Subject: Sunnica – EN010106 Unique Ref nos : AFP191

A G Wright & Son Farms Ltd 28th March 2023

Since Deadline 10 we have received further documents from Natural England. I have attached the documents as appendices and comment as follows:

Natural England ALC mapping request for clarification regarding ALC Grade mapping discrepancies (10/10/2022)

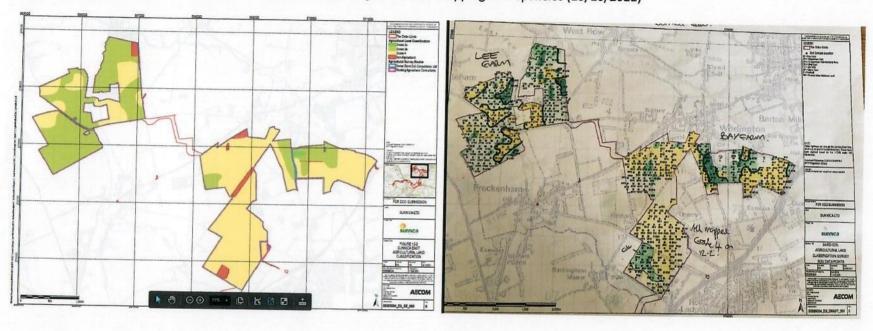
Comparison of Figure 12-2 and the roughly mapped ALC Grades according to the auger bore data provided in Appendix 12B. The attached photo above assumes the ALC Grades provided in Appendix 12B are correct.

There are areas of ALC grades which have been identified in the field by Daniel Baird (Appendix 12B), but not mapped accordingly in Figure 12-2.

Two areas of no ALC data marked by the question marks in the photo (Bay Farm). In figure 12-2, this unsurveyed land is graded a mix of ALC Grade 3a, 3b and 4. How was this grading determined? Would this land be subject to ALC survey prior to construction?

Lee Farm (Sunnica East): an area of Subgrade 3a is not mapped (points LF45, LF60, LF78, LF77, LF89, LF90, LF91, LF102).

Bay Farm (Sunnica East): an area of Subgrade 3a is not mapped (points BF18, BF35, BF54, BF55, BF72, BF87, BF89)

Elms Road (Sunnica East): an area of Subgrade 3a is not mapped (Points ER47, ER48, ER55, ER56, ER63, ER64, ER65, ER73, ER74, ER75, ER85, ER90, ER91)

Likewise, areas of Grade 4 have not been mapped (Lee Farm)

The borehole data should be reviewed and the ALC Mapping across the full site updated where appropriate. If there is a reason why these areas (or any other areas of discrepancy between the ALC grade mapped and the borehole data) have not been mapped, justification needs to be provided.

If the ALC Figures are updated, the areas of each ALC grade should also be updated in the Environmental Statement and ALC Report.
